1201 2nd Avenue - #3019177

2/3 Alley Vacation

Recommendations Meeting / Downtown Design Review Board / 04.05.2016

SKANSKA / **PICKARD CHILTON** / **SWIFT** COMPANY ^{LLC} / **GRAHAM BABA** ARCHITECTS

PROPOSED DEPARTURE #2 - OVERHEAD WEATHER PROTECTION

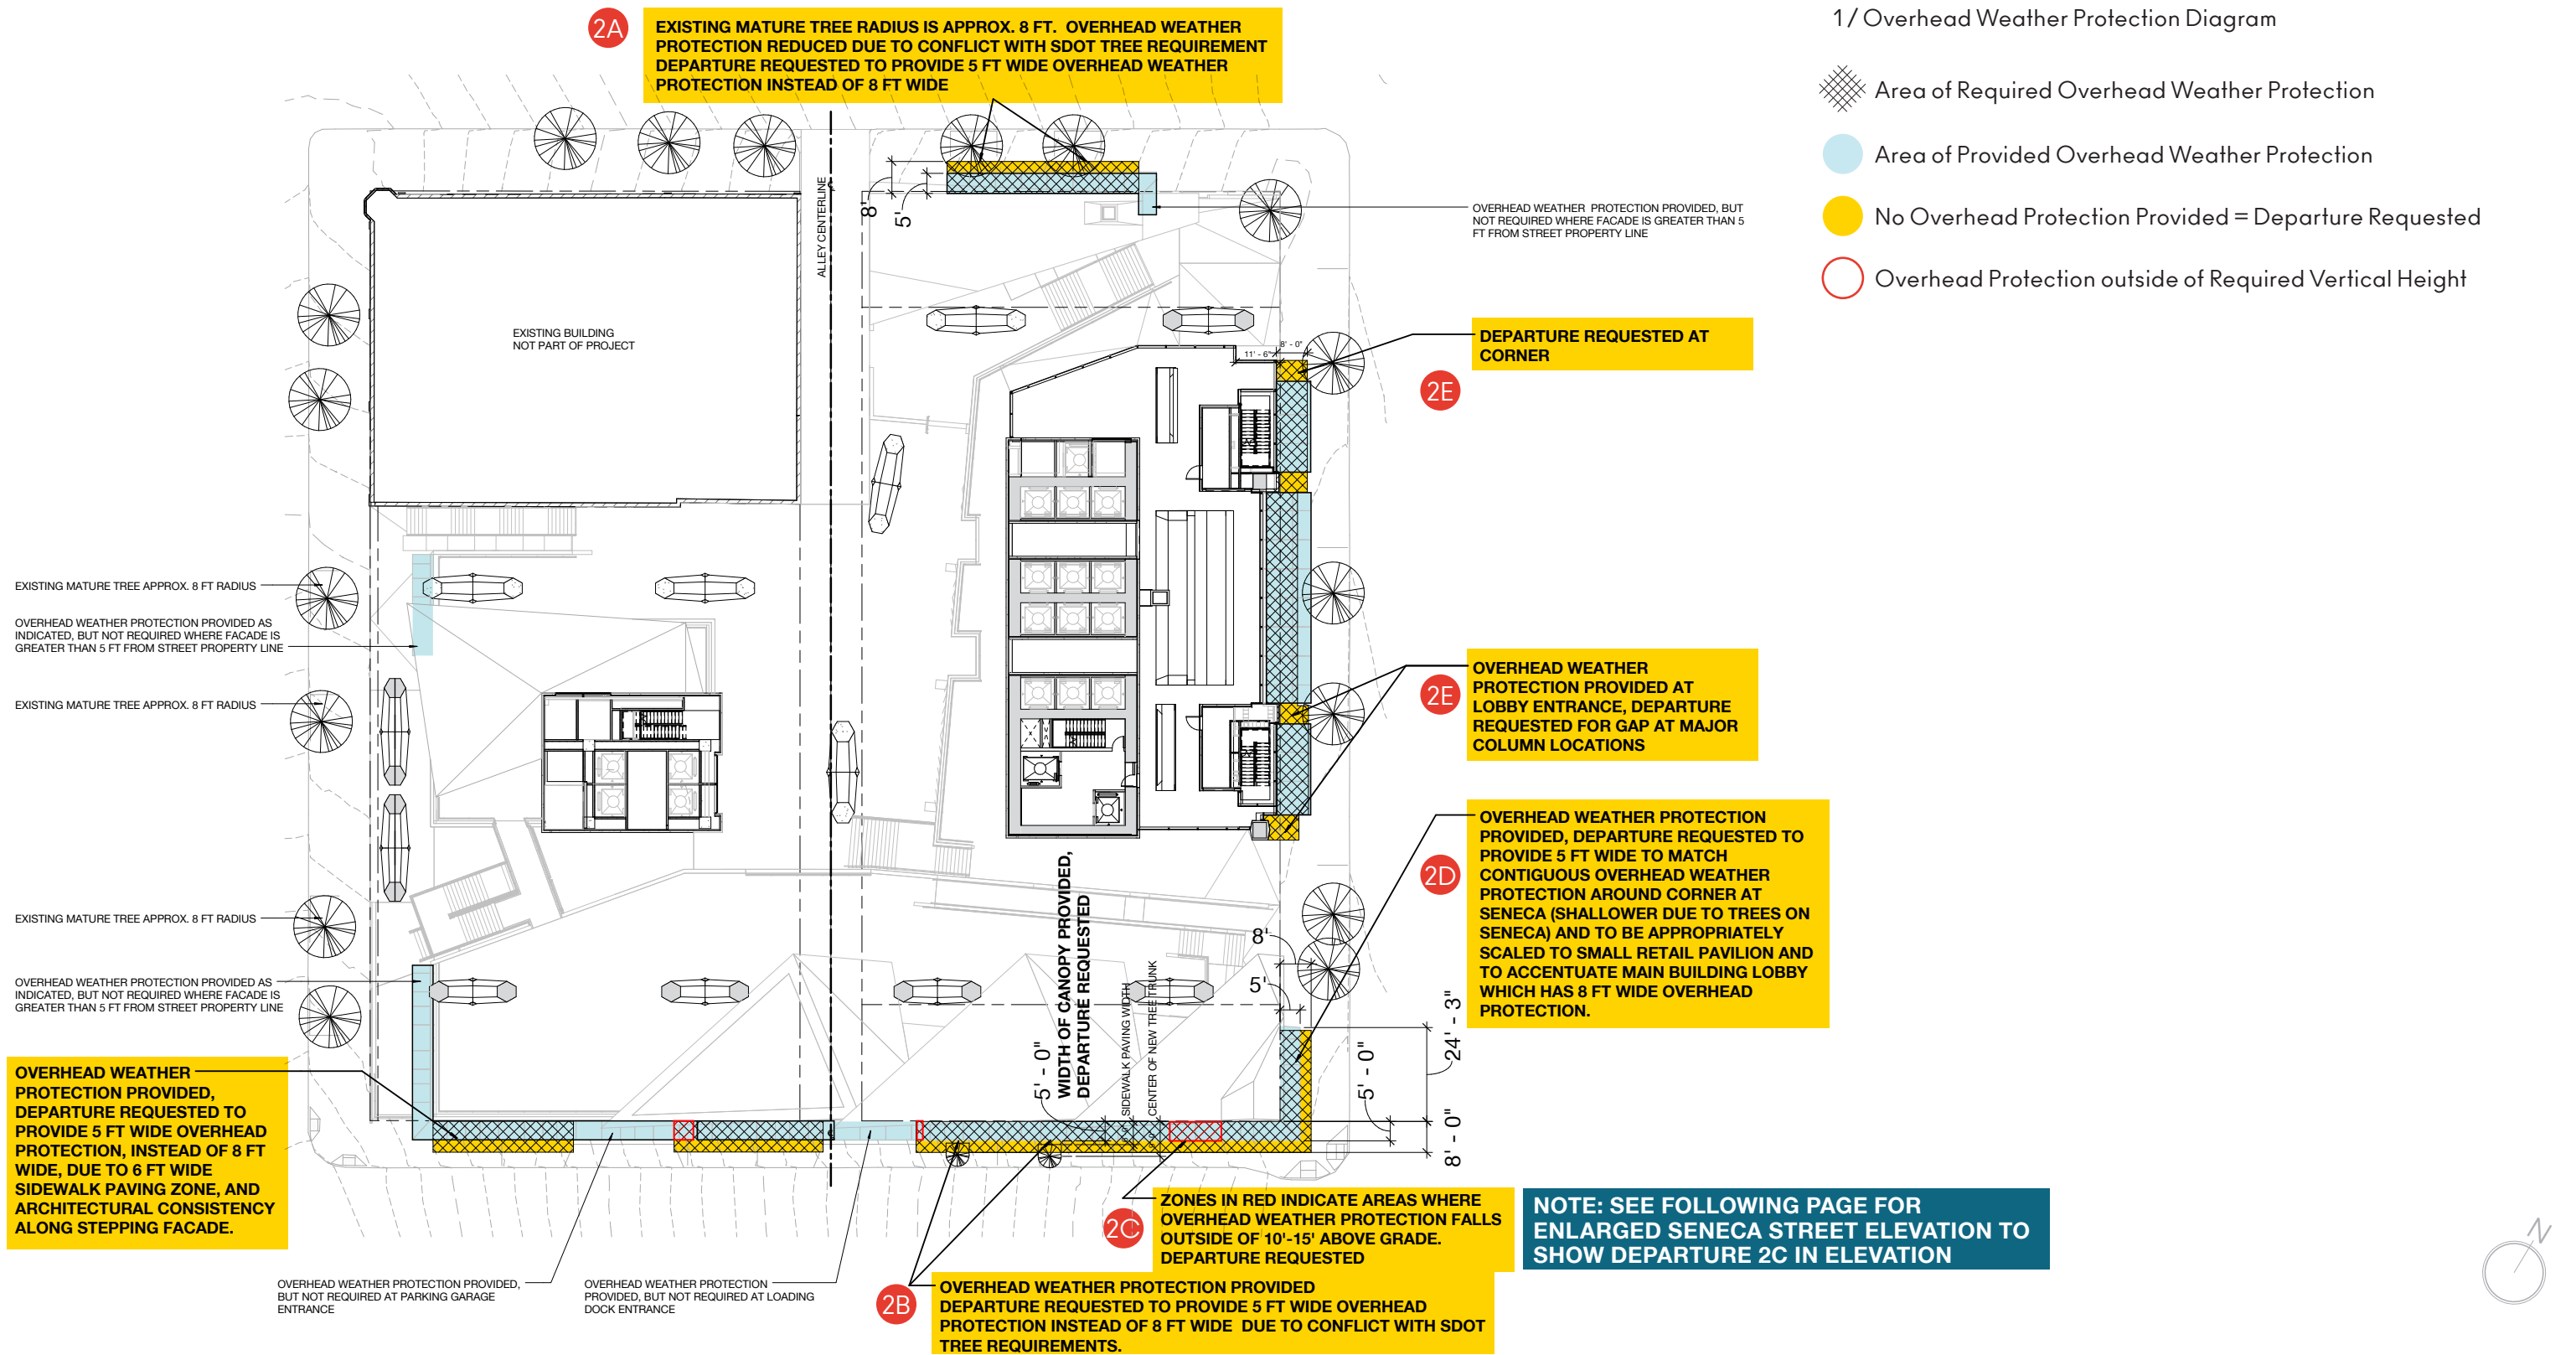
<p>Proposed Design Departure & Rationale</p> <p>2A. UNIVERSITY ST: Proposed to have 5 FT WIDE OVERHEAD WEATHER PROTECTION instead of 8 FT wide DUE TO MATURE TREES.</p> <p>On University St., 8 ft wide overhead weather protection would conflict with mature tree canopies, and require significant pruning. The proposed 5 ft wide canopies, suggested by Land Use Comments, should clear the branches with minimal or no pruning. This street frontage does not include building entries.</p>

2D. SECOND AVE: A 24 FT LONG PORTION of Overhead Protection near the corner of 2nd & Seneca is proposed to be 5 FT WIDE TO CONNECT WITH THE CONTIGUOUS PROTECTION AT SENECA.

2E. SECOND AVE: AT THE MAIN LOBBY FRONTAGE, SEVERAL GAPS are proposed at the main structural articulation, and near the north egress stair. None of these gaps occur at entries.

At the southern corner at Seneca Street, 5 ft wide protection is proposed to match the proposed 5 ft wide protection at Seneca that wraps the corner, and to relate to the small scale of the retail pavilion, in comparison to the 8 ft protection at the main tower lobby entry.

On 2nd Avenue, 8 ft wide protection is provided at the main tower facade, with small breaks proposed in the overhead protection at the columns, to allow the facade articulation to continue to grade, and at the northeast end of the lobby near the exit stair, to focus pedestrian attention to the main tower entry.

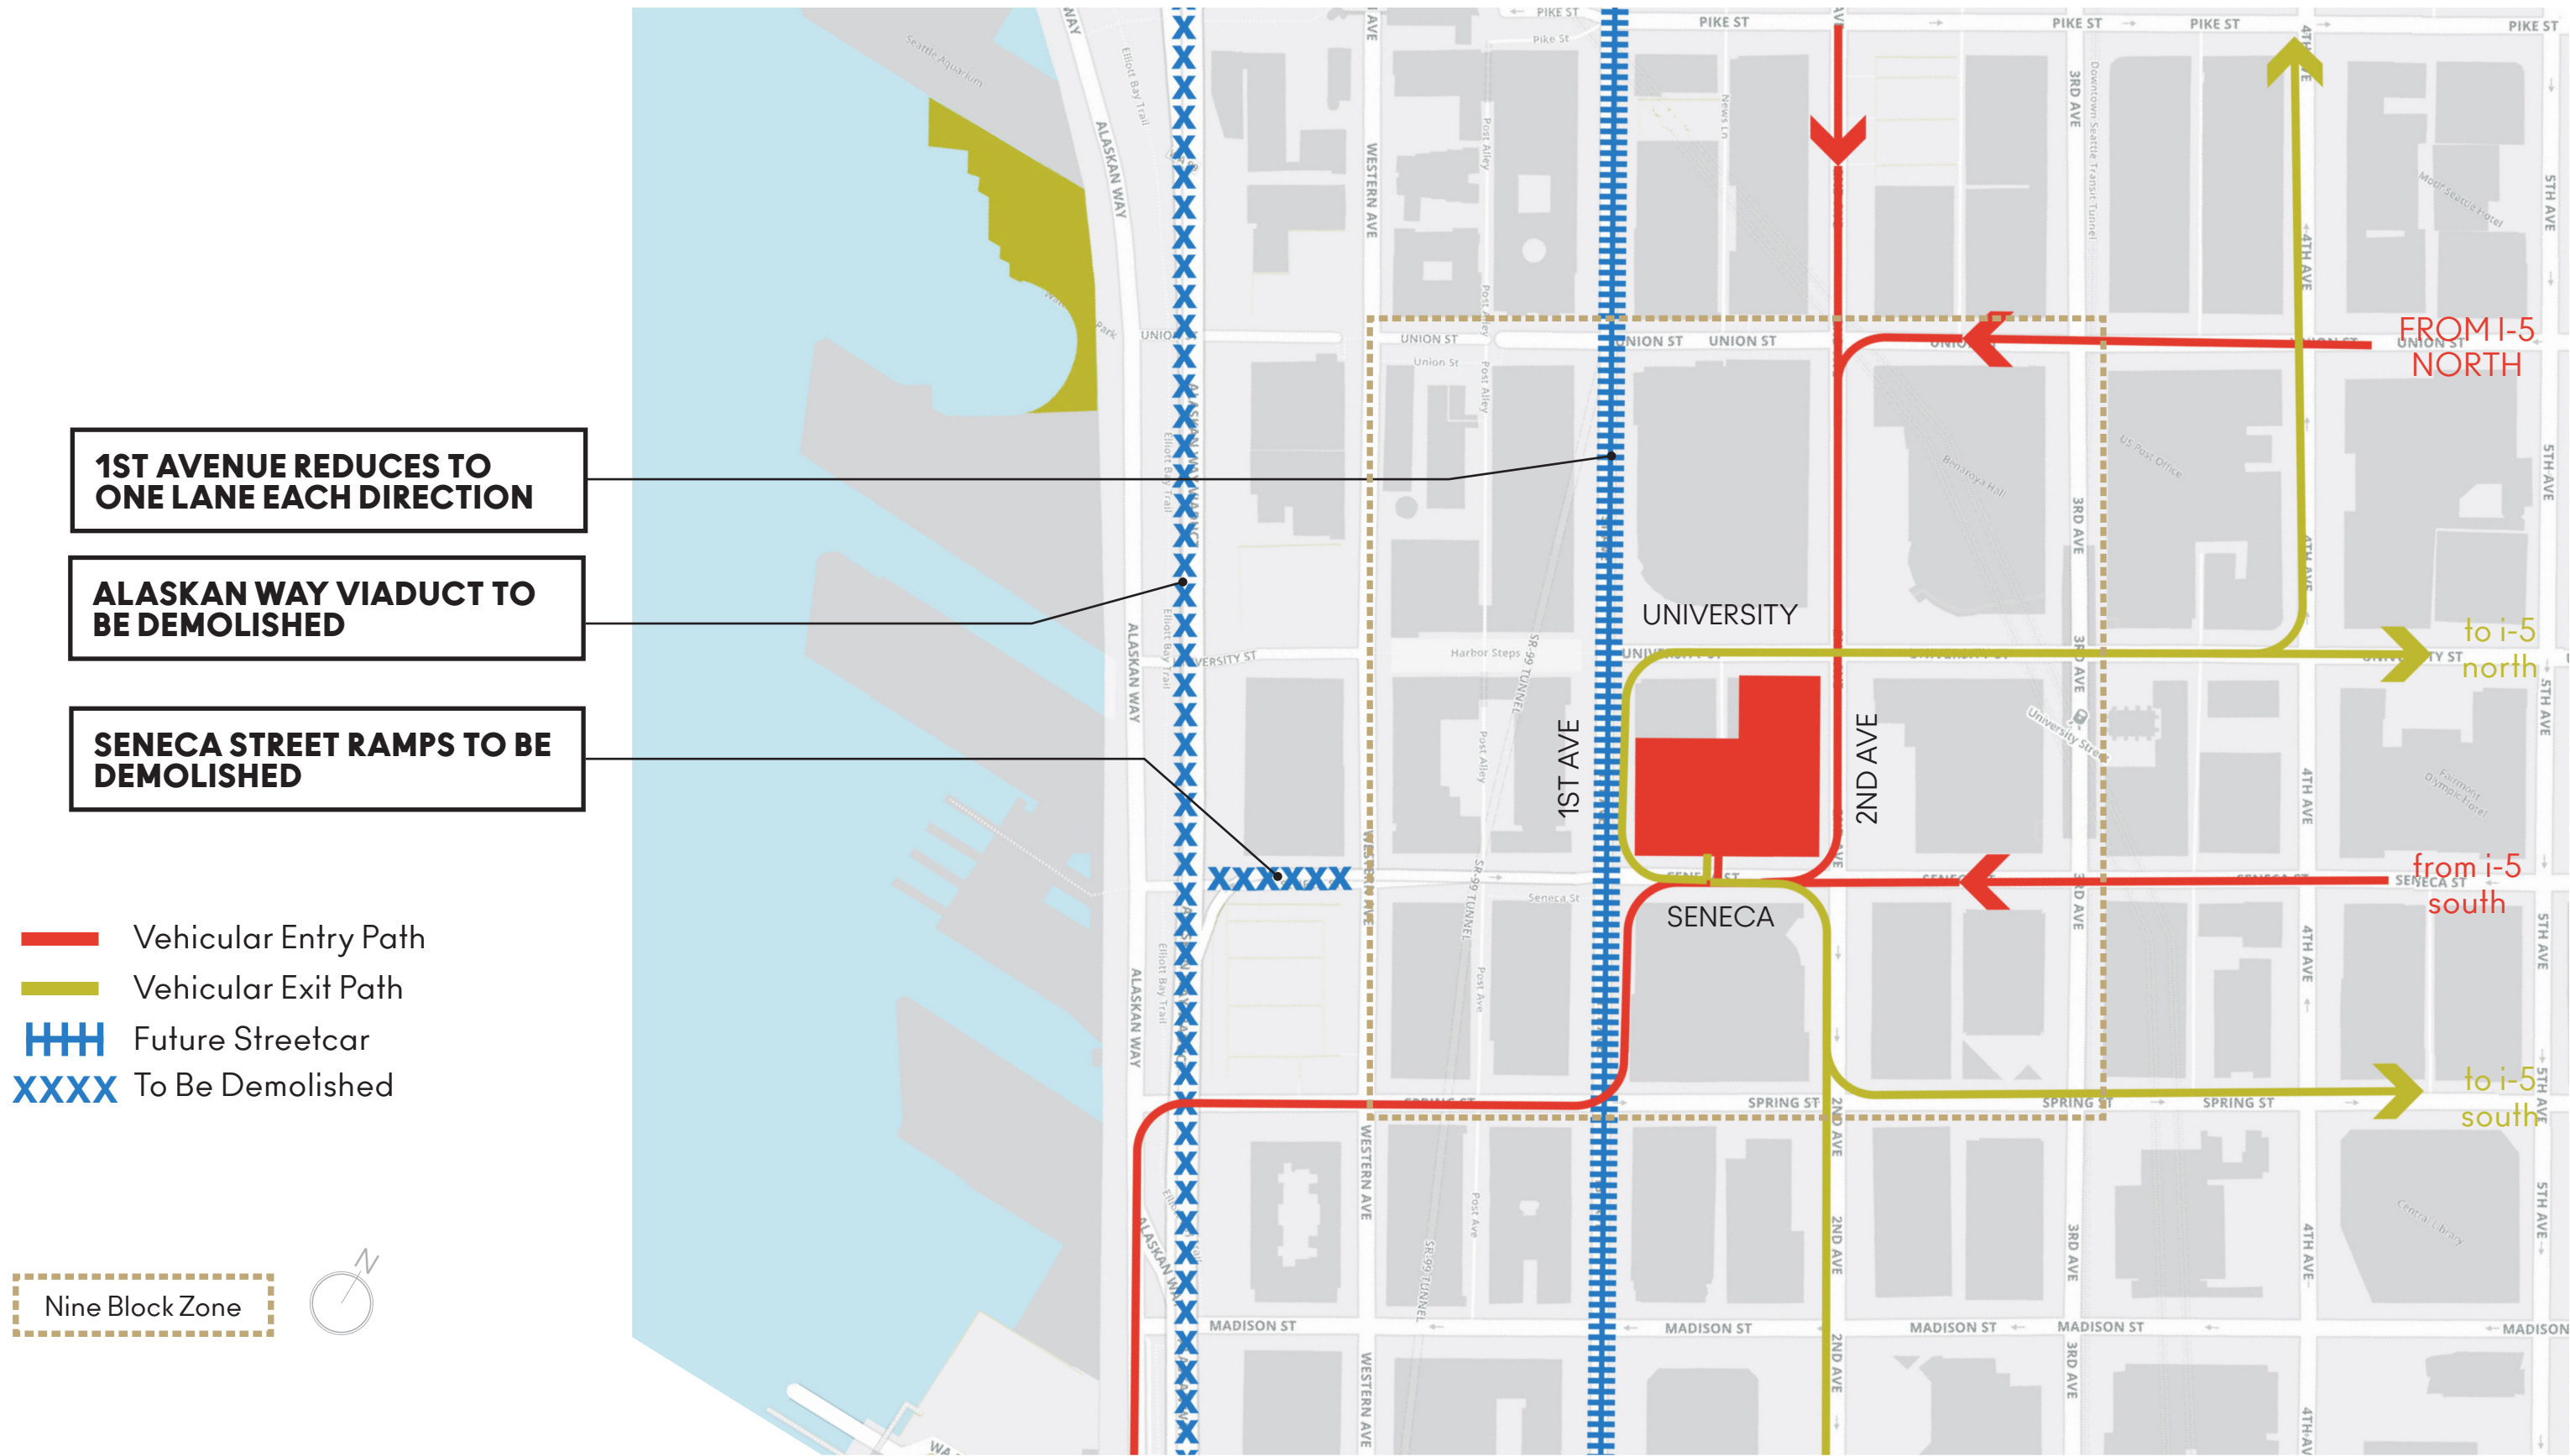
Provide a conceptual landscape plan for the site. As part of this plan, please include information on how the ground plane will be treated and how planting will reinforce pedestrian routes in and through the site.

Provide additional details about the hammerhead design. Project design should show how the hammerhead relates to alley function, how pedestrian movement will be accommodated, and how it reinforces the open space network.

A landscape plan was provided which included information on how the ground plane will be treated in terms of planting, materials, and pedestrian infrastructure to reinforce pedestrian routes through the site from the five entrance points.

The Commission approved the project team’s response to all three recommended actions during a subcommittee meeting on November 16, 2015.
